March 8, 2007

McGuire Nuclear Station, Units 1 and 2
Docket Nos. 50-369 and 50-370

License Amendment Request Revising McGuire Units 1 and
2 Updated Final Safety Analysis Report Commitments to
USNRC Regulatory Guide 1.82, Revision 0, "Sumps For
Emergency Core Cooling and Containment Spray Systems"
and Revising McGuire Units 1 and 2 Technical
Specification Surveillance Requirement (SR) 3.5.2.8
and Associated Bases

Figure 1
 Original ECCS Sump Strainer
 (UFSAR Figure 6-196)

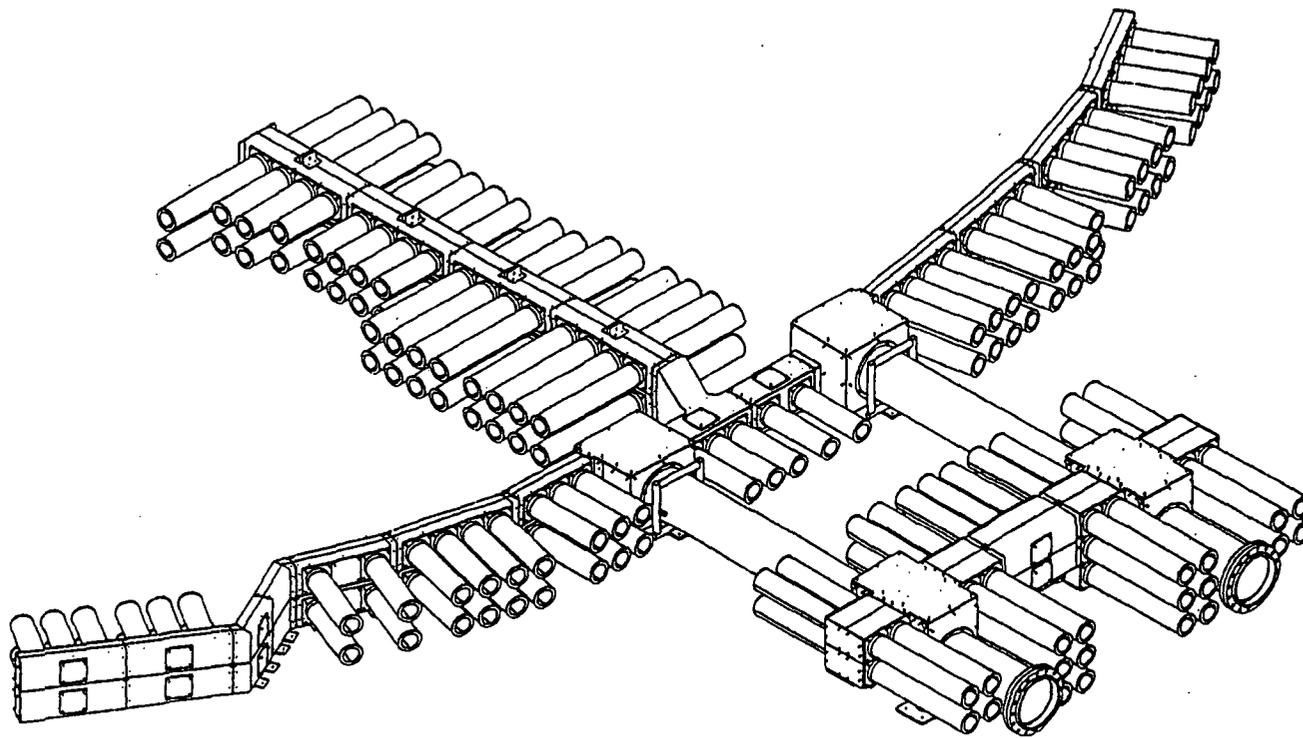
The as-built configuration of the McGuire Unit 1 ECCS containment sump structure (and original Unit 2 ECCS containment sump structure) is illustrated by McGuire UFSAR Figure 6-196 (see Figure 1 of Attachment 4). For each Unit, the ECCS containment sump structure consists of stainless steel framing that provides the structure for attachment of a stainless steel fine mesh inner screen and an outer trash rack grating. A solid top deck is provided.

The train-specific suction pipes exit lower containment through horizontal penetrations incorporating guard pipes. Each open-ended sump suction inlet line originates in the interior of its train-specific strainer enclosure (see Figure 1). The net screen surface area provided by both ECCS trains is approximately 135 square feet, or 67.5 square feet per train.

Figure 2

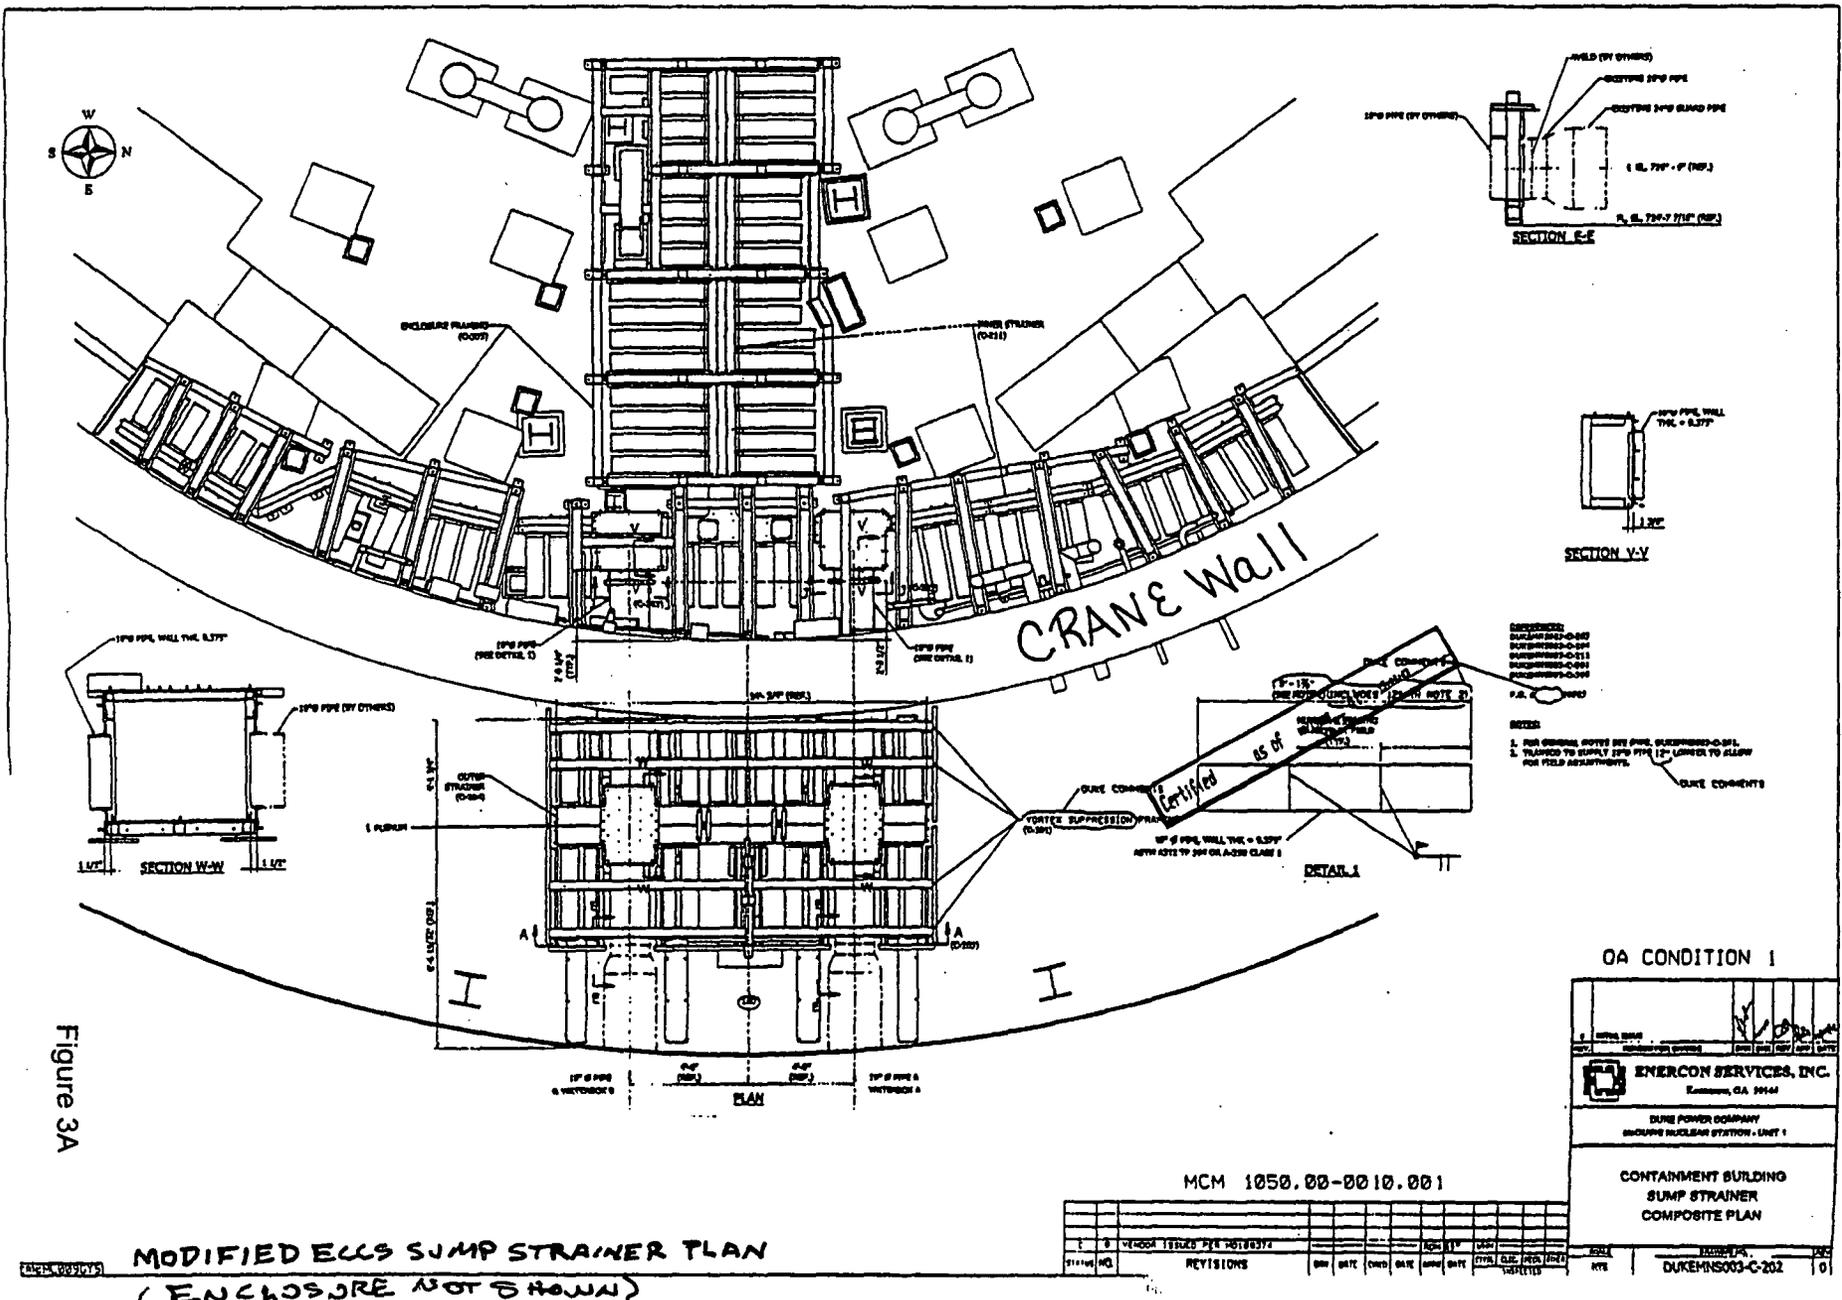
The McGuire strainer modification removes the original ECCS containment sump structure described above and replaces it with a complex strainer assembly located inside and outside the crane wall (see Figures 2, 3A and 3B of Attachment 4). The plenums and strainer portions located Inside the Crane Wall (ICW) are housed within a stainless steel enclosure that preserves the original 'remote sump' design.
